AGENDA
HAILEY PLANNING & ZONING COMMISSION
Tuesday, January 22, 2019
Hailey City Hall
5:30 p.m.

STAFF REPORT

TO: Hailey Planning & Zoning Commission
FROM: Lisa Horowitz Director
RE: Richard Nelson – Request for Variance Extension
HEARING: January 22, 2019

STAFF REPORT
Hailey Planning and Zoning Commission
Regular Meeting of January 22, 2019

**SWEETWATER
 PARCEL B2
 SITE PLAN**

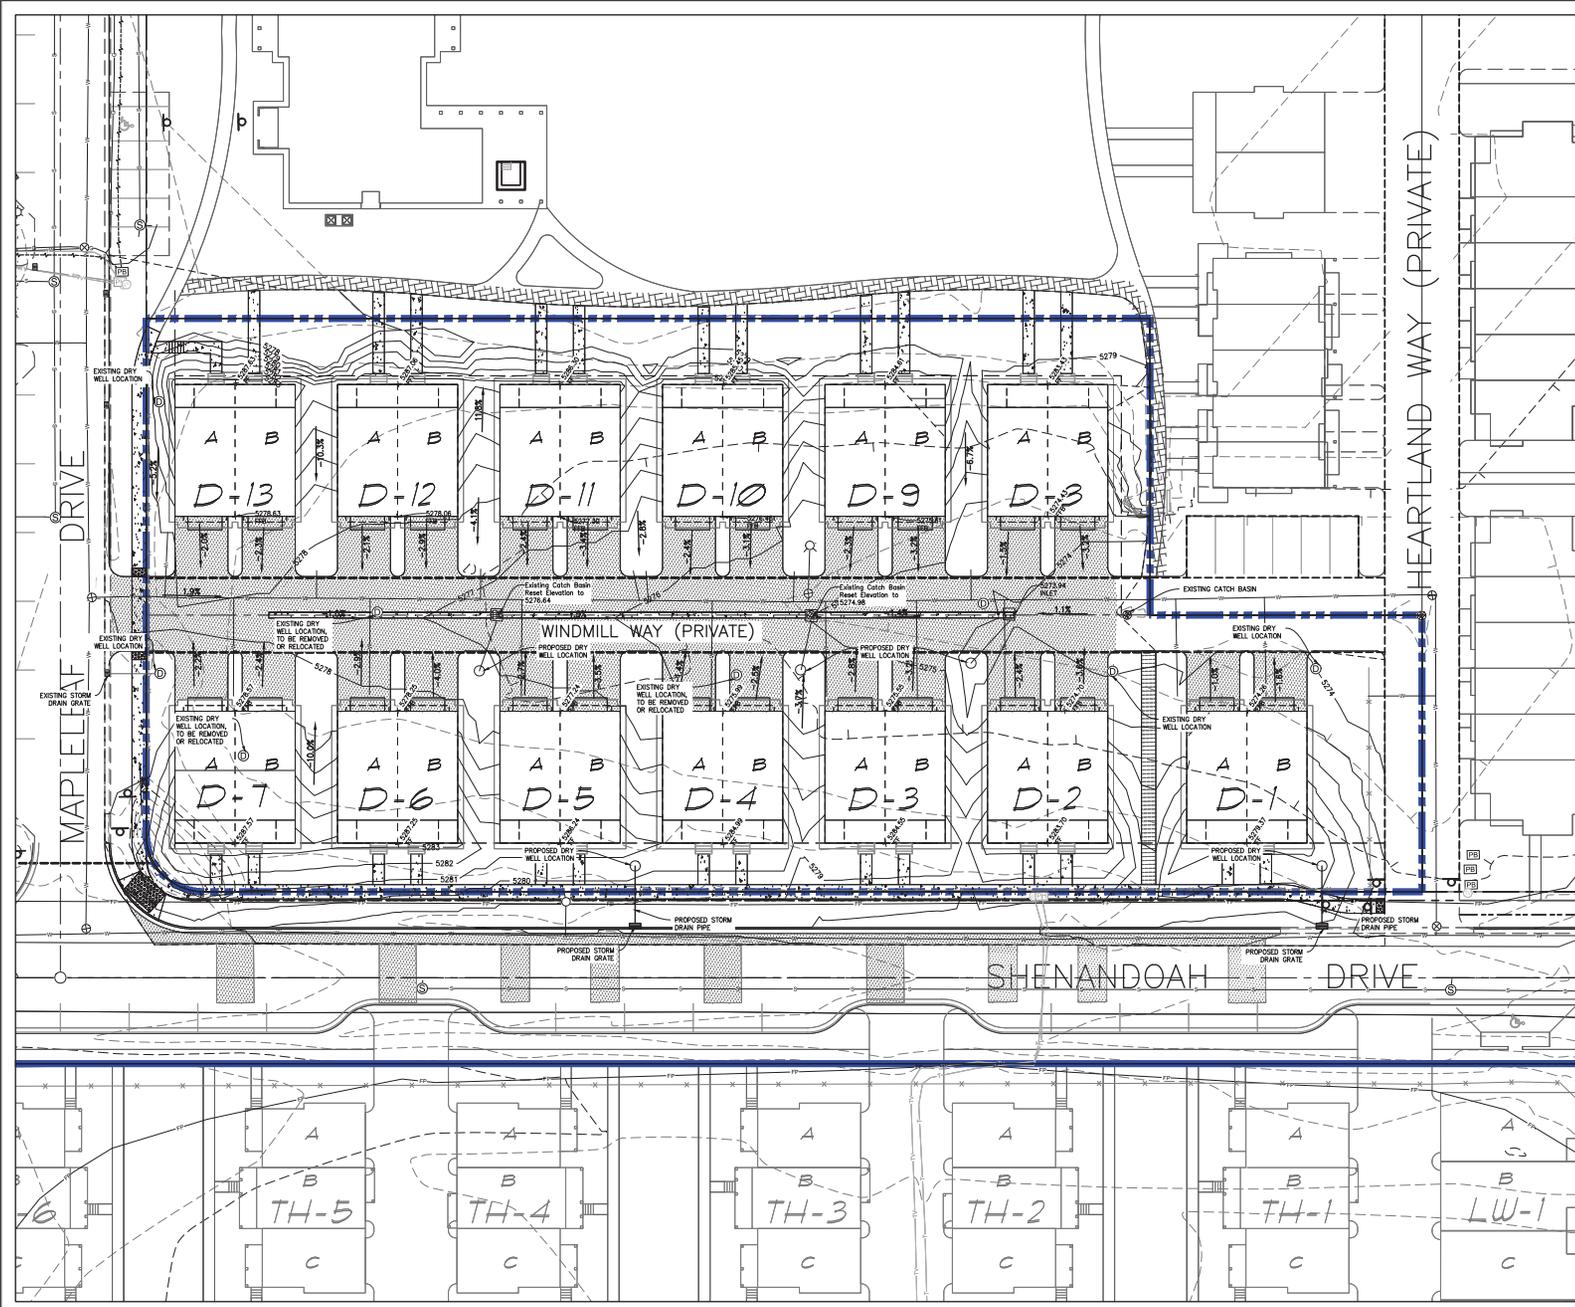
<i>Staff Comments</i>	<i>The site plan proposes 20,110 square feet of parking, hardscape and pedestrian circulation. 25% of 20,110 square feet is approximately 5,028 square feet. 5,130 square feet for snow storage is provided. This is shown on the plans.</i>
<input checked="" type="checkbox"/>	<input type="checkbox"/>	<input type="checkbox"/>	17.06.080(A)1j	j. Snow storage areas shall not be less than 25% of the improved parking and vehicle and pedestrian circulation areas.
			<i>Staff Comments</i>	<i>See Standard (i) above.</i>
<input checked="" type="checkbox"/>	<input type="checkbox"/>	<input type="checkbox"/>	17.06.080(A)1k	k. A designated snow storage area shall not have any dimension less than 10 feet.
			<i>Staff Comments</i>	<i>The proposed snow storage area is greater than 10'-wide.</i>
<input checked="" type="checkbox"/>	<input type="checkbox"/>	<input type="checkbox"/>	17.06.080(A)1l	l. Hauling of snow from downtown areas is permissible where other options are not practical.

**SWEETWATER
 PARCEL B2
 LIGHTING PLAN**

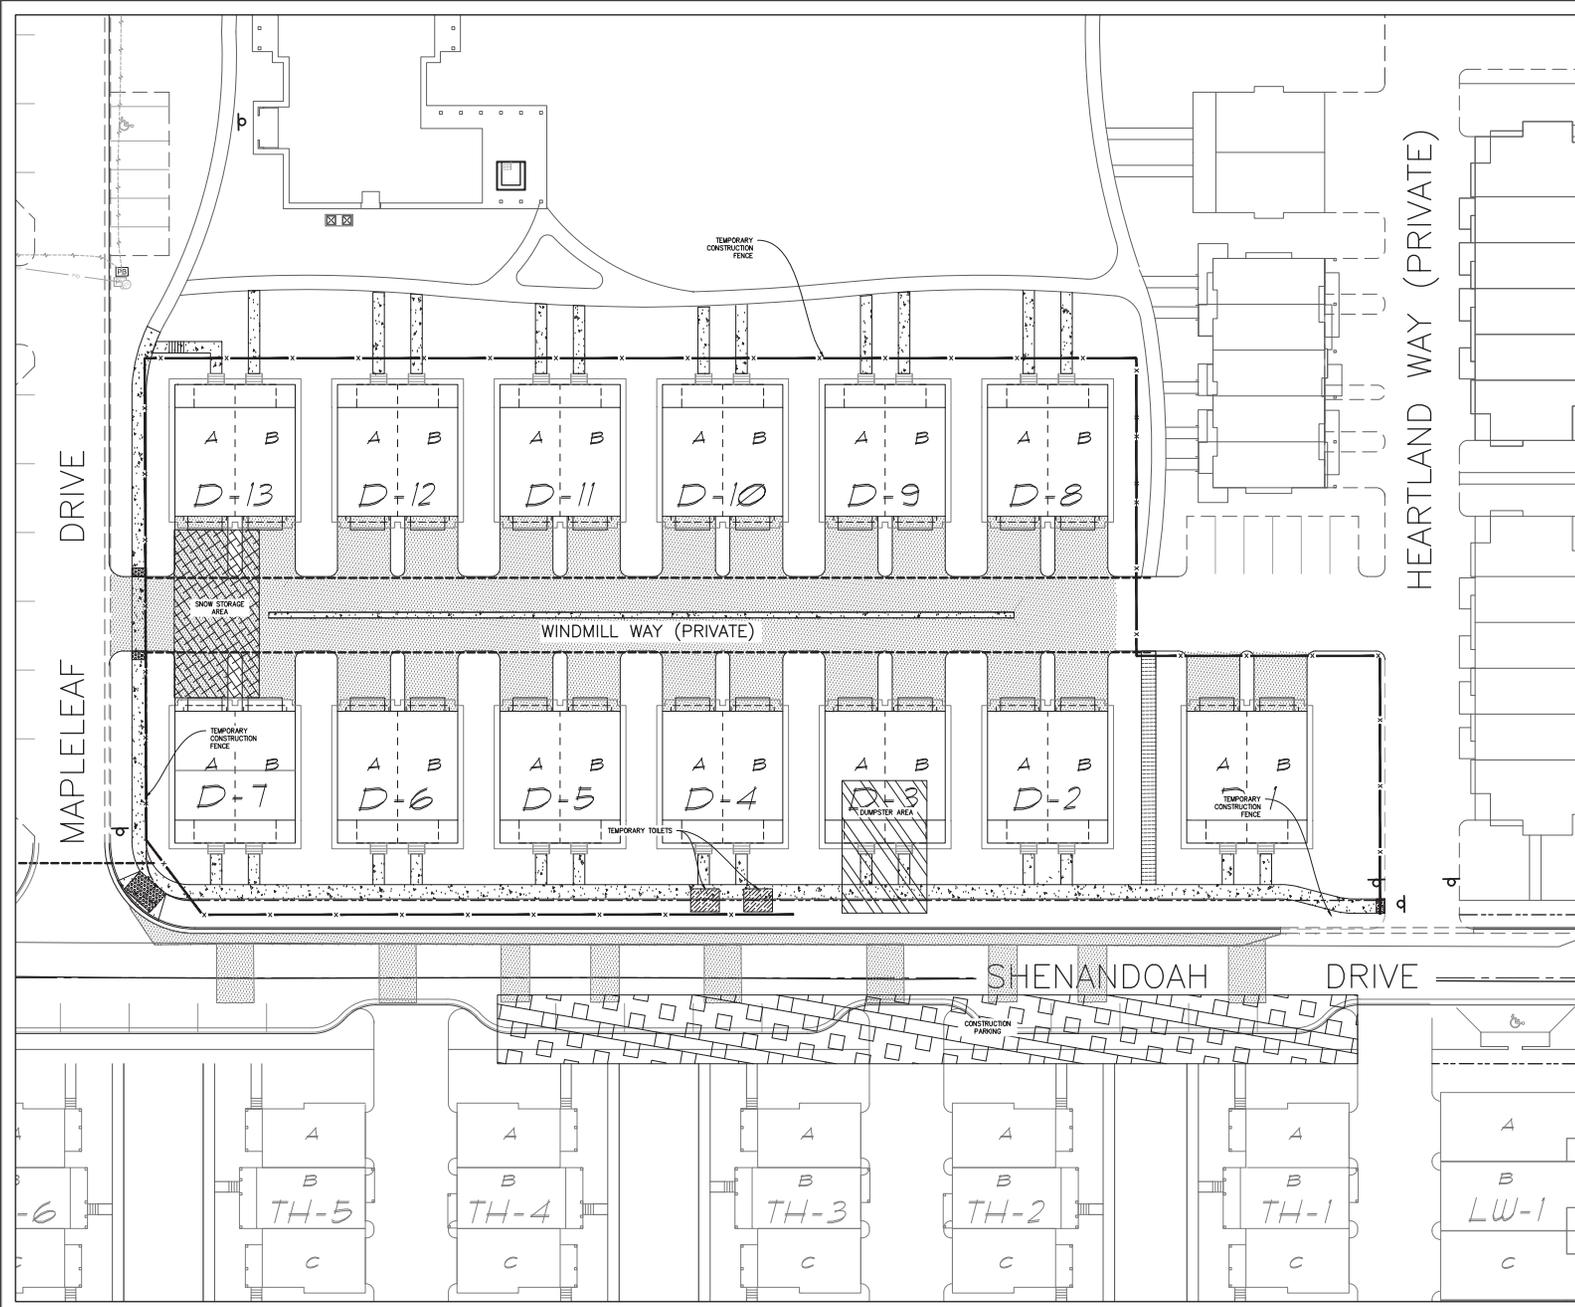
<p>5. Skyglow.</p> <p>b. All non-essential exterior commercial and residential lighting is encouraged to be turned off after business hours and/or when not in use. Lights on a timer are encouraged. Sensor activated lights are encouraged to replace existing lighting that is desired for security purposes.</p> <p>c. Canopy lights, such as service station lighting shall be fully recessed or fully shielded so as to ensure that no light source is visible from or causes glare on public rights of way or adjacent properties.</p> <p>d. Area lights. All area lights are encouraged to be eighty-five (85) degree full cut-off type luminaires.</p> <p>e. Idaho Power shall not install any luminaires after the effective date of this Article that lights the public right of way without first receiving approval for any such application by the Lighting Administrator.</p>
			<p><i>Staff Comments</i></p> <p>The Applicant will install Dark Sky compliant, downcast and low wattage fixtures. A fixture sample has been submitted.</p>
